CALIFORNIA COASTAL COMMISSION

**STAFF REPORT: DE NOVO & REGULAR CALENDAR**

APPLICATION NUMBER: 5-00-351 **APPEAL NUMBER:** A-5-VEN-01-272

PROJECT LOCATION: 3511 Via Dolce, Venice, City of Los Angeles.

EXHIBIT # 4

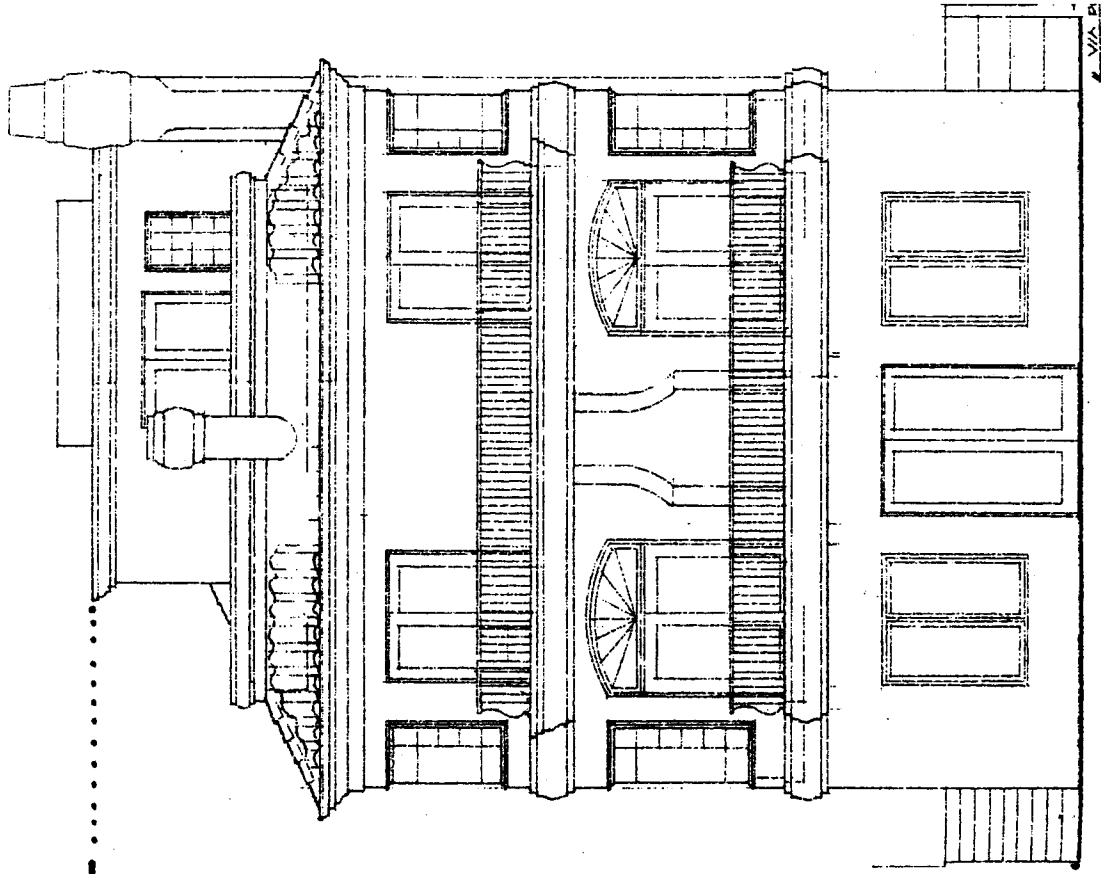
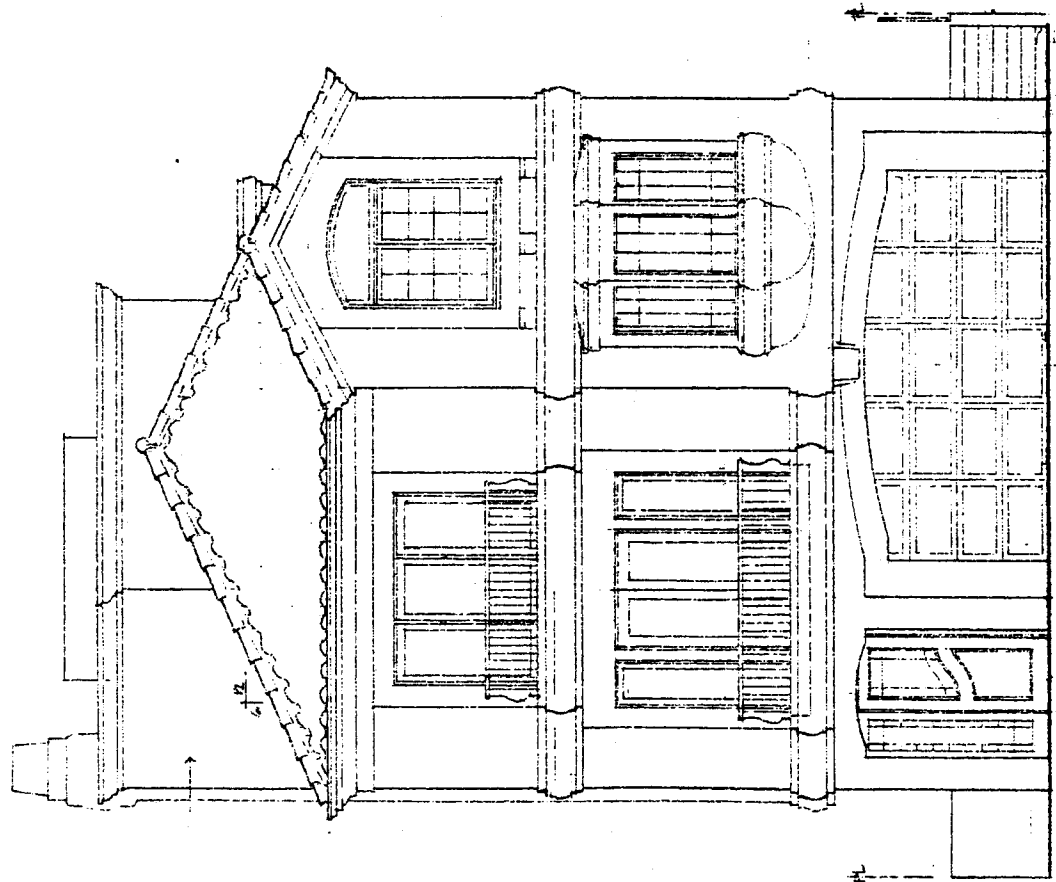
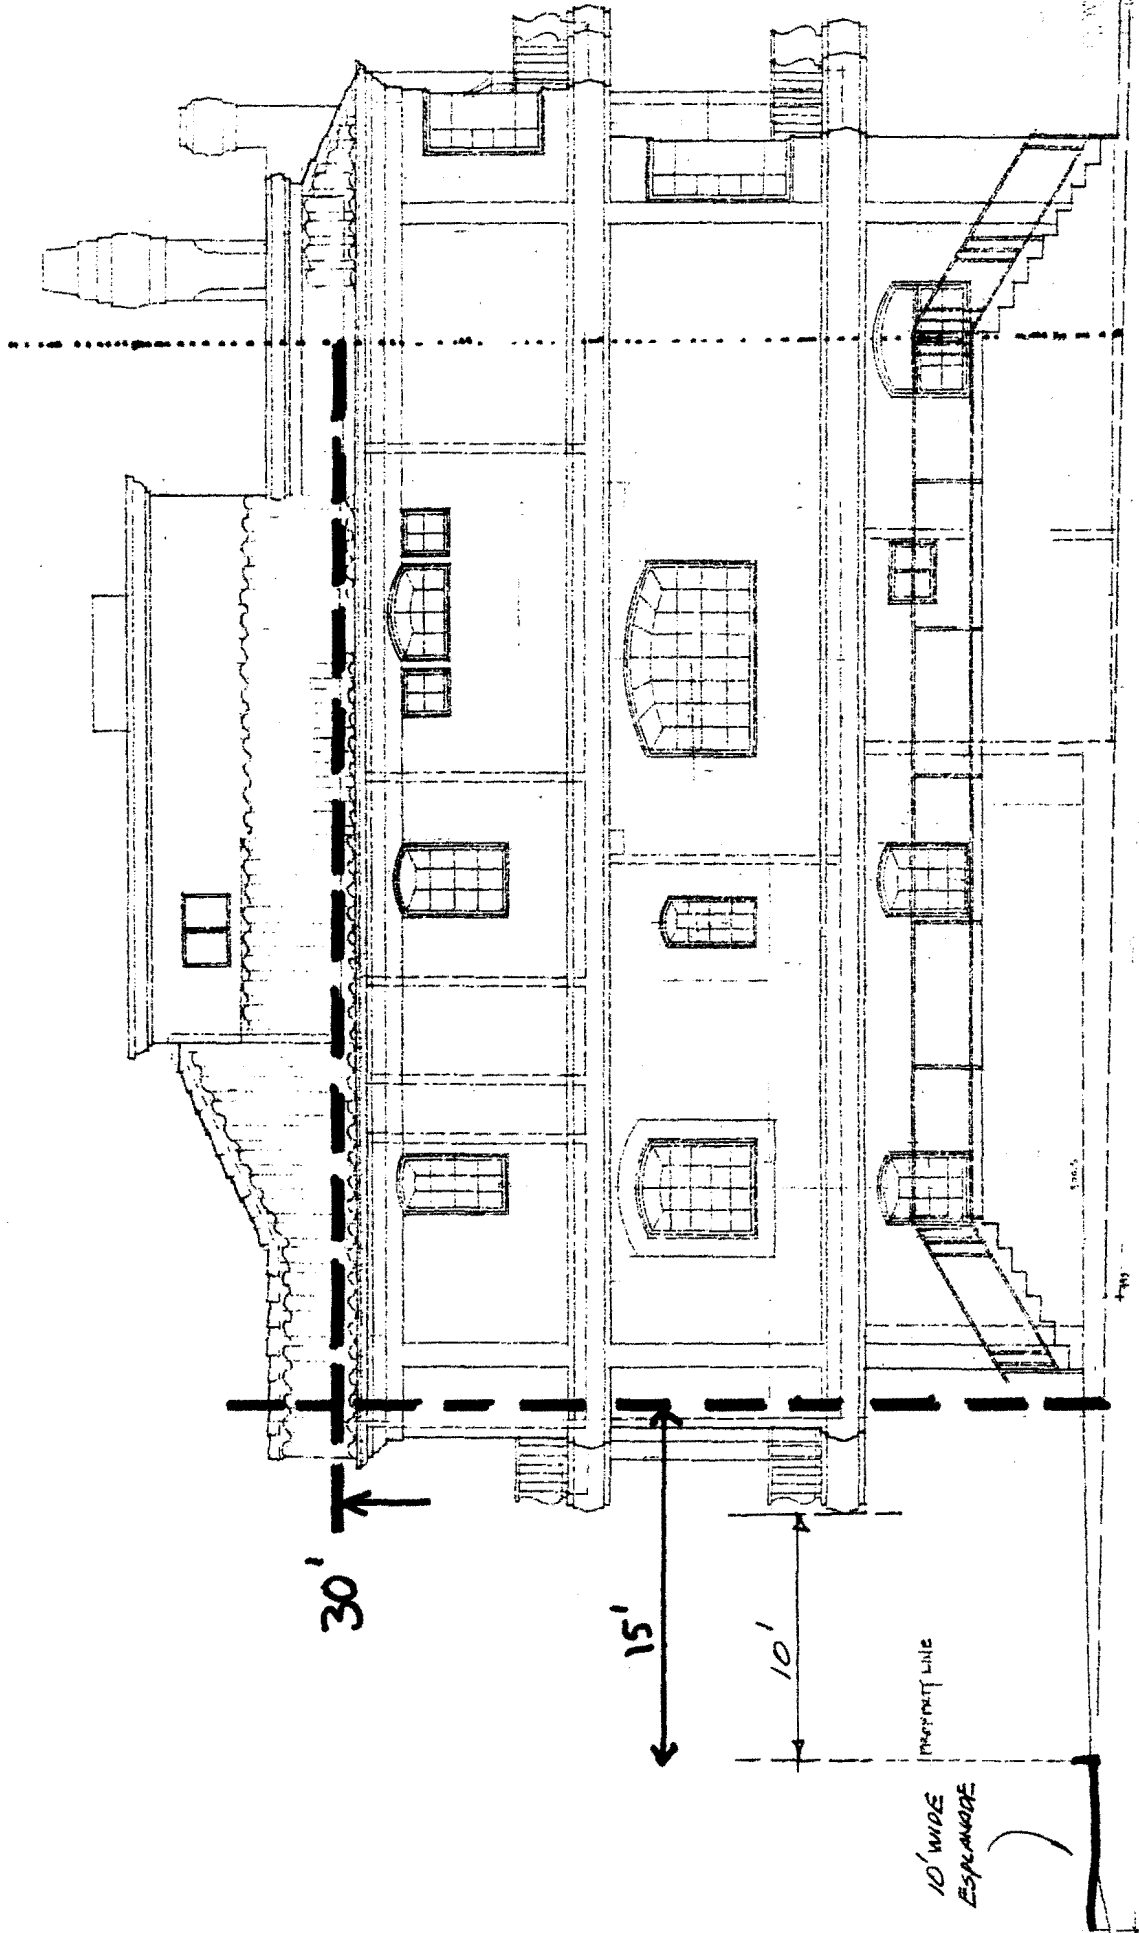
The applicant has proposed a 40-foot high (as measured above the frontage road, Via Dolce) single family home (Exhibit #4 & #5). This height is inconsistent with the Commission's most recent actions limiting development in this area at 30 feet within 60 horizontal feet of the inland side of the Esplanade (City right-of-way) [See CDP Nos. 5-01-118, 5-01-119, 5-01-120, 5-01-121, 5-01-122, 5-01-123, 5-01-377, and the policies within the Venice LUP]. The applicant has stated that constructing a project consistent with the Commission's requirements would create a box-like structure, lacking architectural character and a roof access, washer/drier, and storage room. Commission staff analyzed the applicant's request to construct a roof access, washer/drier, and storage room and sloped roofline above 30 feet within 60 horizontal feet of the inland side of the Esplanade. It was found that the applicant can construct a reasonably sized home in compliance with the provisions found in the Land Use Plan for Venice consistent with the Chapter Three policies of the Coastal Act. The proposed fourth level, containing the roof access, laundry, and storage room, is approximately 320.5 square feet. Subtracting the fourth level from the proposed home still allows for an approximately 3,846.5 square foot home. As discussed below, increasing the canal fronting setback (consistent with the Venice LUP) would reduce the size of the home by an additional approximately 91 square feet. Therefore, the total reduction of the single family home would be approximately 411.5 square feet, allowing a 3,755.5 square foot single family home on a 2,908 square foot lot. Allowing structures above the height limit required in past Commission action and in the policies of the Land Use Plan for Venice would impact the scenic and visual quality of the Grand Canal (East) Neighborhood in a manner inconsistent with Section 30251.

The applicant has proposed a single family home with a 14.5-foot first and second floor setback and a 12.5-foot third floor setback from the canal property line (Exhibit #3 & #5). The applicant has also proposed second and third floor, overhanging balconies that are located within 10 feet of the canal property line.

The proposed single-family residence provides only a ten-foot front yard setback (Exhibit #3 & #5). Therefore, Special Condition #2 requires the applicant to provide revised plans demonstrating the provision of a 525 square foot, permeable front yard consistent with prior Commission approvals and the requirements of the Venice LUP. In order to maintain an open and visible access corridor, enhance visual quality, preserve the water quality, and to protect the biological productivity of Grand Canal, an uncovered and permeable yard area totaling no less than 525 square feet shall be provided and maintained in the front yard area between the structure and the front (canal) property line. The area within the required front yard setback (fifteen-foot average setback with ten-foot minimum setback) shall be maintained as the required permeable yard area. Uncovered means that no fill or building extensions (e.g. balconies, stairs, trellises, etc) shall be placed in or over the 525 square foot permeable yard area with the exception of fences, garden walls or permeable decks. The total combined height of any deck, deck railings, garden walls and/or fences situated within the required permeable front yard area shall not exceed 6 feet above the elevation of the adjacent public walkway.

(ii) Building Height. The height of the structure within sixty horizontal feet of the inland side of the Esplanade (City right-of-way) shall not exceed thirty (30') feet above the centerline of the frontage road (Via Dolce). Beyond 60 horizontal feet, one foot in additional height is permitted for each two additional horizontal feet to a maximum height of 38 feet above the centerline of the frontage road (Via Dolce). No portion of any structure (including roof access structures, roof deck railings and architectural features) shall exceed the thirty-foot height limit within sixty horizontal

for bird flyways the Commission requires the applicant, prior to issuance of the permit, to submit revised plans reducing the height of the proposed project. Special Condition #2 states that the height of the structure within sixty horizontal feet of the inland side of the Esplanade (City right-of-way) shall not exceed thirty (30') feet above the centerline of the frontage road (Via Dolce). Beyond 60 horizontal feet, one foot in additional height is permitted to a maximum height of 38 feet above the centerline of the frontage road (Via Dolce). No portion of any structure (including roof access structures, roof deck railings and architectural features) shall exceed the thirty-foot height limit within sixty horizontal feet of the inland side of the Esplanade. Chimneys, exhaust ducts, ventilation shafts and other similar devices essential for building function may exceed the specified height limit by five feet.
